# UNITED STATES PATENT AND TRADEMARK OFFICE

10/522,965

Mircea Gradu

<b>Office Action Summary</b>	<b>Application No.</b>	<b>Applicant(s)</b>	
	10/522,965	GRADU, MIRCEA	
	<b>Examiner</b>	<b>Art Unit</b>	
	David D. Le	3681

**S. Patent No. 5,083,986 to Teraoka et al.**

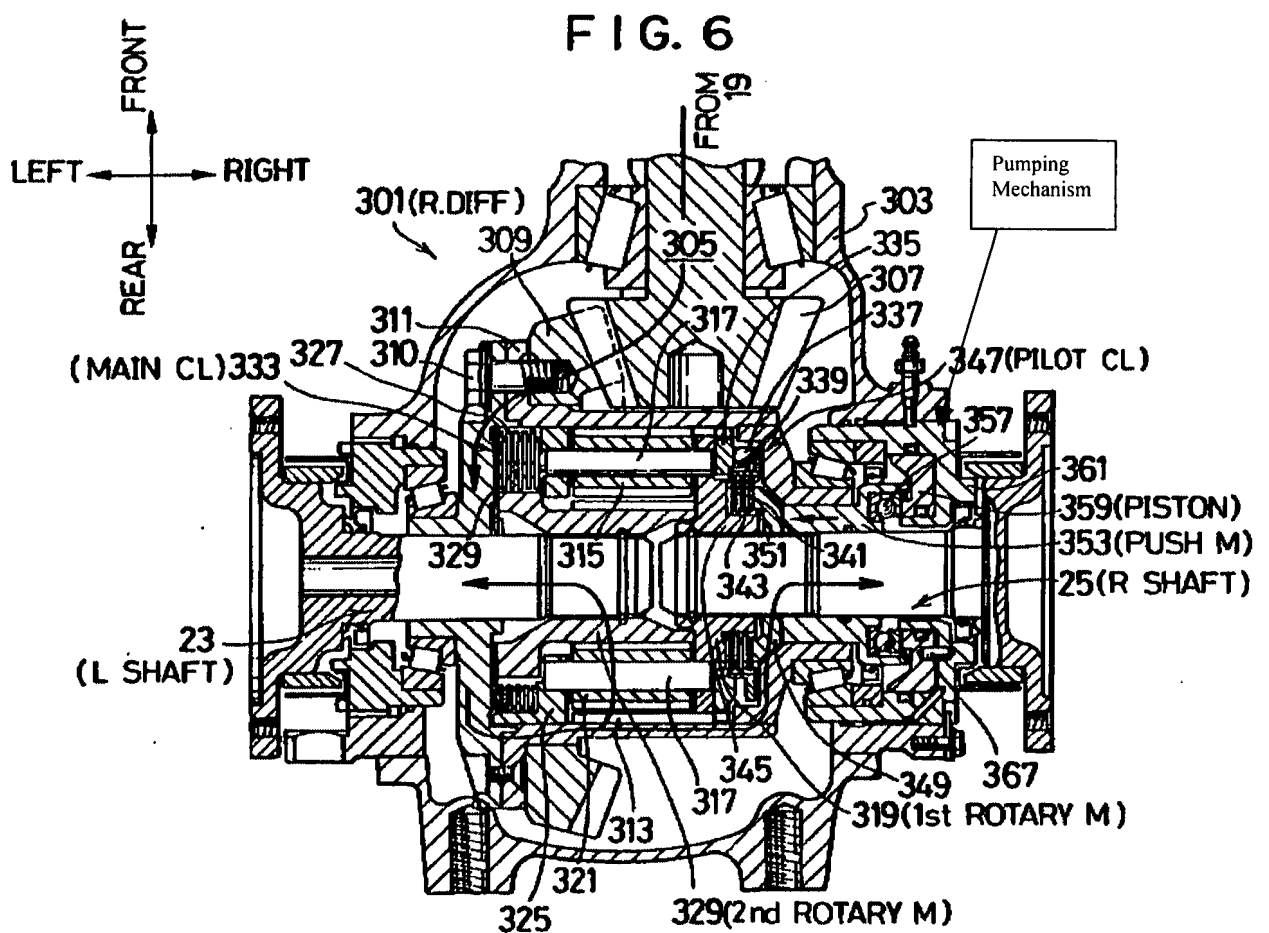
***Teraoka*** (i.e., Figs.2 and 6; column 5, line 54 – column 14, line 9) discloses a differential assembly comprising:

- An input shaft (i.e., Fig. 6, element 311) adapted to be connected to a source of torque (i.e., Fig. 2, element 1 and 3);
- An output shaft (i.e., Fig. 6, element 25) from which torque is delivered, the input shaft (311) and the output shaft (25) having a common axis of rotation (i.e., Fig. 6);

- A clutch (i.e., Fig. 6, element 333) having a first clutch member (i.e., Fig. 6, being the outer friction plates 327) and a second clutch member (i.e., Fig. 6, being the inner friction plates 327) capable of rotating at different angular velocities, the clutch (333) configured for transferring torque between the first and second clutch members when the first and second clutch members rotate at different angular velocities, the first and second clutch member being operatively connected to the input shaft (311);

- A pumping mechanism (i.e. Fig. 6; element Pumping Mechanism above) configured to engage the first and second clutch members of the clutch (333) when the first and second clutch members rotate at different angular velocities;

- A planetary set (i.e., Fig. 6, element 301) including a first element (i.e., Fig. 6, element 313), a second element (i.e., Fig. 6, element 329), a third element (i.e., Fig. 6, element 319), and a fourth element (i.e., Fig. 6, being the combination of elements 315 and 321) organized about the common axis of rotation, the first element (313) operatively connected to the first clutch member and to the input shaft, the second element (329) connected to the second clutch member, the third element (319) connected to the output shaft (25), and the fourth element operatively connected between the first element and the second element, and between the second element and the third element;

- Wherein the input shaft (311), the first element (313), the third element, the fourth element, and the output shaft define a second torque path;
- Wherein the pumping mechanism includes an external gear (i.e., Fig. 6, element 335) operatively coupled to the second clutch member, an internal gear (i.e., Fig. 6, being the right portion of element 313 that engages with element 335) coupled to the input shaft, an axial cam plate (i.e., Fig. 6, element 353), and a piston (i.e., Fig. 6, element 359);

- A locking mechanism (i.e., Fig. 6, element 347) configured to maximize torque transfer between the input shaft and the output shaft;
- Wherein the locking mechanism (347) is disposed in parallel with the clutch (333) between the first and second elements of the planetary set;
